Addendum 43: Regulation No. 44

Revision 2 – Corrigendum 2

UNIFORM PROVISIONS CONCERNING THE APPROVAL OF RESTRAINING DEVICES FOR CHILD OCCUPANTS OF POWER-DRIVEN VEHICLES ("CHILD RESTRAINT SYSTEM")

Figure 1

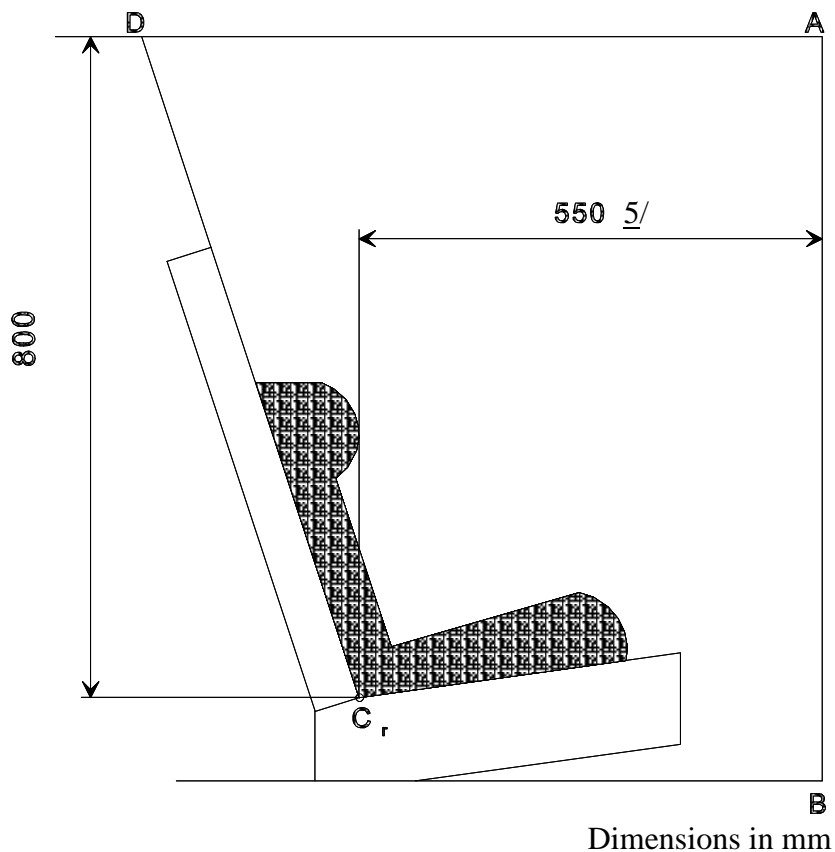
Paragraph 7.1.4.4.1.1., figure 1, insert a reference to a footnote 5/ to the 550 dimension, and insert the corresponding footnote 5/, to read:

5/ For the purpose of the test specified in paragraph 7.1.4.1.10.1.1., this dimension shall be 500 mm."
